City of Beaumont Wastewater Treatment Plant Salt Mitigation Upgrade Project Change Order No. 16

PCO-33	
Design Adjustment:	CLAR – 24
WML COP-036R2	Modifications to Equalization Basin and Solid Handling Building

Subject: EQ Basin Modifications

Subject: EQ Basin Modifications Location: Civil and EQ Basin

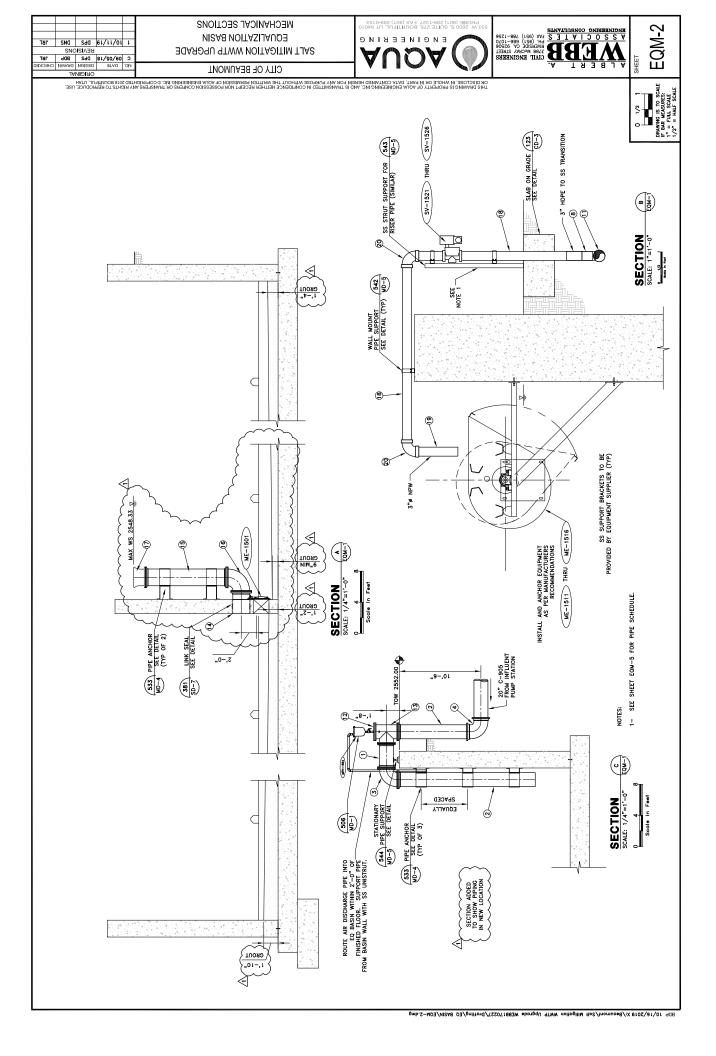
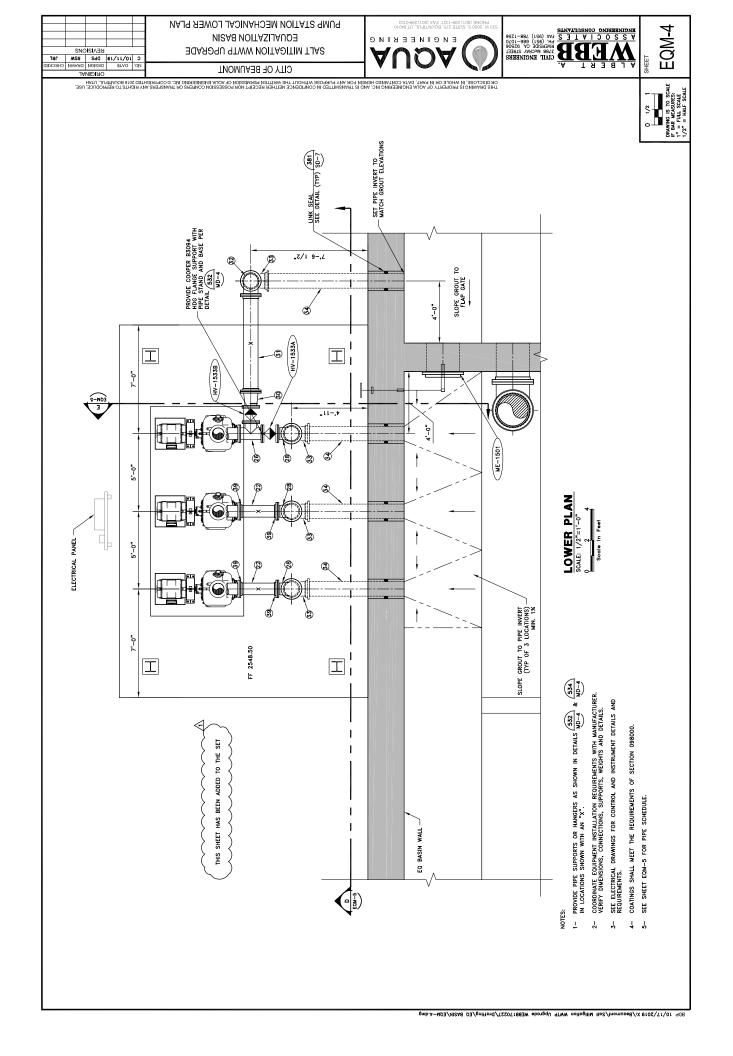
pipe deleted
EQM-2	Grout dimension added. 24" pipe location updated; detail added for 20" influent pipe
EQM-3	New sheet added.
EQM-4	New sheet added.
FSS-1	New sheet added. Updated 24" pipe to 30" pipe. Added 16" pipe.
FSS-2	Updated 24" pipe to 30" pipe. Added 16" pipe.
FSS-5	Updated grating support dimensions.
FSM-1	Updated manhole and drain lines locations. Added 16" line from eq basin.
FSM-3	Added pipe numbers to the Pipe Schedule
FSM-4	New sheet added showing 16" pipe from EQ basin
SCH-19	Schedule updated with additional valves
SCH-24	Schedule updated with additional meter
SCH-26	Schedule updated with additional pumps
PI-04	Removed valve vault and associated equipment removed. Routed Equalization Basin communications
	through RIO-SH, instead of RIO-HW
PI-04A PI-05	Added sheet to show EQ Basin Pumps Added piping from Equalization Basin to Fine Screens
	Removed inputs/outputs from valve vault. Relocated EQ Basin level alarms.

OVERALL SITE PLAN SE-01 **ELECTRICAL - SITE** ENGINEERING SALT MITIGATION WWTP UPGRADE 09/05/18 MPJ DCL CITY OF BEAUMONT DRAWING IS TO SCALE
1. BAR MEASURES:

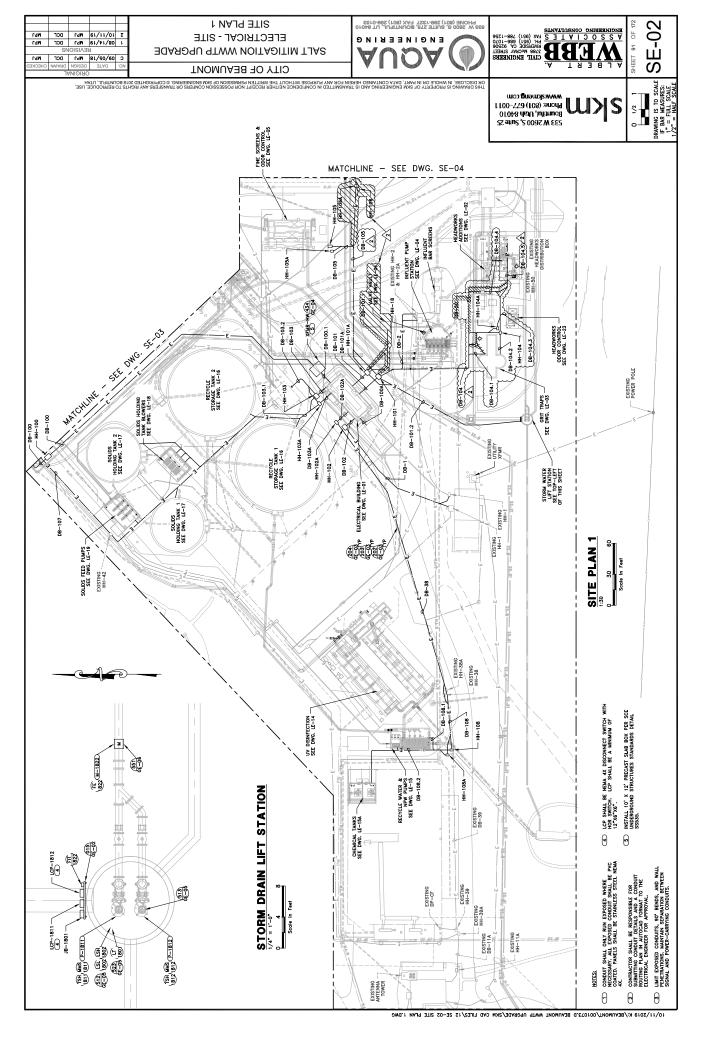
I-14	Feedback added for EQ Basin Flow and Odor Control instrumentation.
I-18	Added inputs/outputs for Equalization Basin instrumentation.
SE-01	Renamed and relocated handholes HH-106 and HH-106A to HH-303 and HH-303A.
	Removed HH-106 and HH-106A, ductbanks DB-101.1 and DB-50, and valve vault. Relocated
SE-02	ductbanks DB-104 and DB-104.1 and handhole HH-104. Added handhole HH-104A and ductbanks DB-

SITE PLAN 3 ELECTRICAL - SITE SALT MITIGATION WWTP UPGRADE CITY OF BEAUMONT

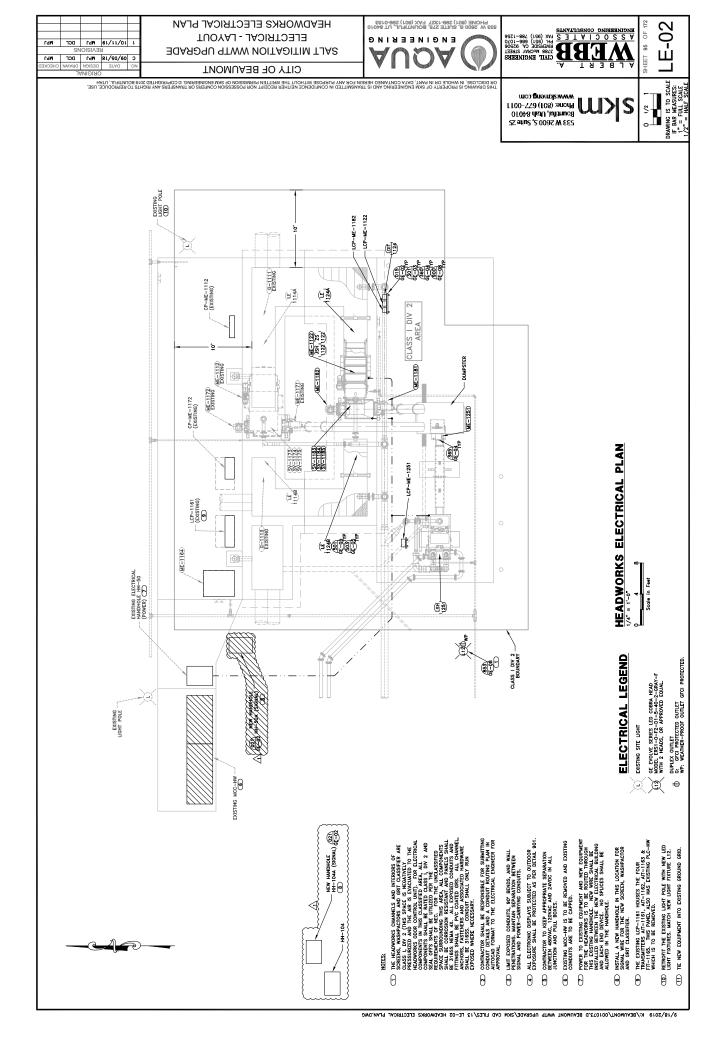
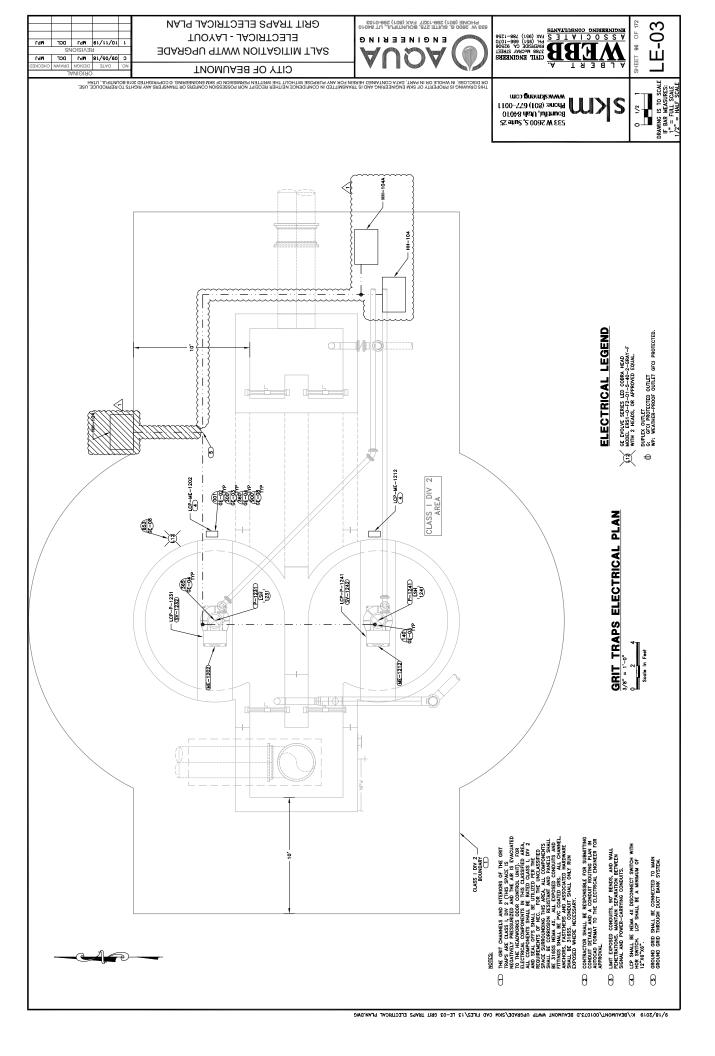
104.4 and DB-104.5.
SE-04	Rotated Equalization Basin. Added EQ Basin Pump Station, handholes HH-303, HH-303A, and
	ductbanks DB-303.3, and DB-303.2. Removed DB-106.
LE-02 LE-03	Removed handhole HH-50A. Relocated handhole HH-104. Added handhole HH-104A. Relocated handhole HH-104. Added handhole HH-104A.
LE-U3	Removed valve vault and handholes HH-106 and HH-106A. Rotated Equalization Basin. Added EQ
LE-06	Basin Pump Station and handholes HH-303 and HH-303A.
LE-20	Updated MCC-SH layout. Added MCC-EQ, Generator Receptacle Enclosure and MTS-SH.
E-03	Removed valve FV-1533.
	Removed valve FV-1533. Relocated LP-SH from SWBD-SH. Added connection to MCC-EQ from SWBD-SH.
E-03 E-10 E-11	Relocated LP-SH from SWBD-SH. Added connection to MCC-EQ from SWBD-SH. Updated MCC-SH layout. Added MCC-EQ. Relocated LP-SH to MCC-EQ.
E-03 E-10 E-11 E-12	Relocated LP-SH from SWBD-SH. Added connection to MCC-EQ from SWBD-SH. Updated MCC-SH layout. Added MCC-EQ. Relocated LP-SH to MCC-EQ. Removed valve FV-1533. Updated loads for SWGR-HW and DP-HW1.

WCC-SH ONELINE 61/11/01 2 ELECTRICAL - POWER DISTRIBUTION SALT MITIGATION WWTP UPGRADE CITY OF BEAUMONT

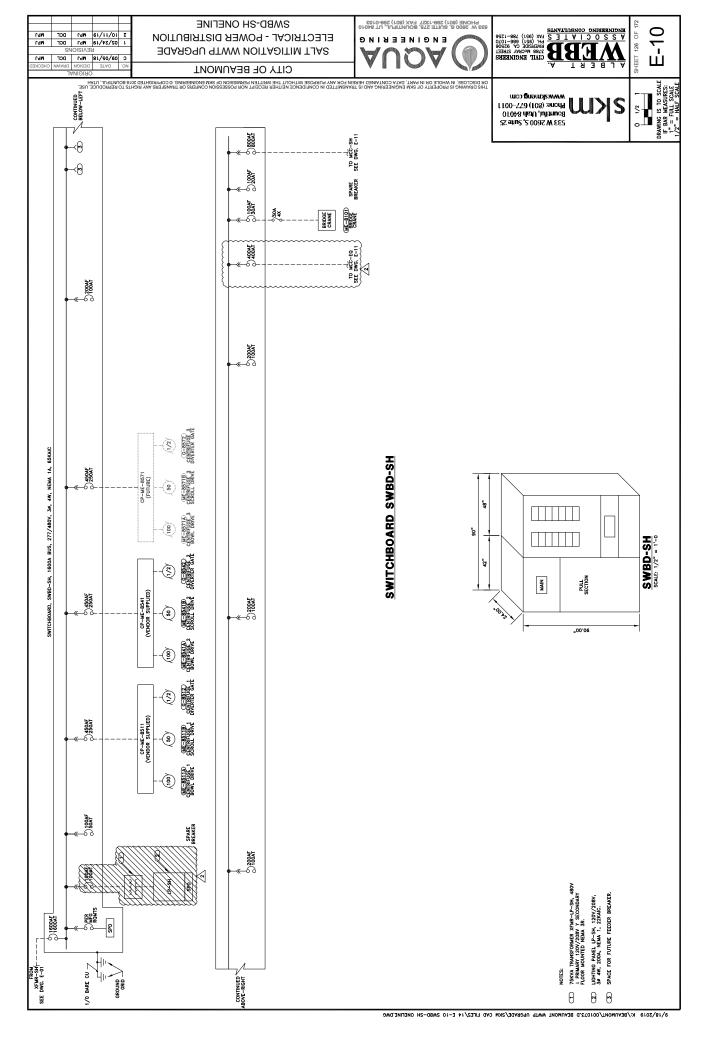
E-03 E-10 E-11	Relocated LP-SH from SWBD-SH. Added connection to MCC-EQ from SWBD-SH. Updated MCC-SH layout. Added MCC-EQ. Relocated LP-SH to MCC-EQ. Removed valve FV-1533. Updated loads for SWGR-HW and DP-HW1. Removed LIT-1501 and LIT-1502. Updated loads at LP-HW1, LP-HW2 and MVSWGR.
E-03 E-10 E-11 E-12	Relocated LP-SH from SWBD-SH. Added connection to MCC-EQ from SWBD-SH. Updated MCC-SH layout. Added MCC-EQ. Relocated LP-SH to MCC-EQ. Removed valve FV-1533. Updated loads for SWGR-HW and DP-HW1. Removed LIT-1501 and LIT-1502. Updated loads at LP-HW1, LP-HW2 and MVSWGR. Added loads for MCC-EQ. Added EQ Basin Pump Station equipment to LP-SH load. Removed load for
E-03 E-10 E-11 E-12 E-13	Relocated LP-SH from SWBD-SH. Added connection to MCC-EQ from SWBD-SH. Updated MCC-SH layout. Added MCC-EQ. Relocated LP-SH to MCC-EQ. Removed valve FV-1533. Updated loads for SWGR-HW and DP-HW1. Removed LIT-1501 and LIT-1502. Updated loads at LP-HW1, LP-HW2 and MVSWGR. Added loads for MCC-EQ. Added EQ Basin Pump Station equipment to LP-SH load. Removed load for solids building lighting from SWBD-SH.
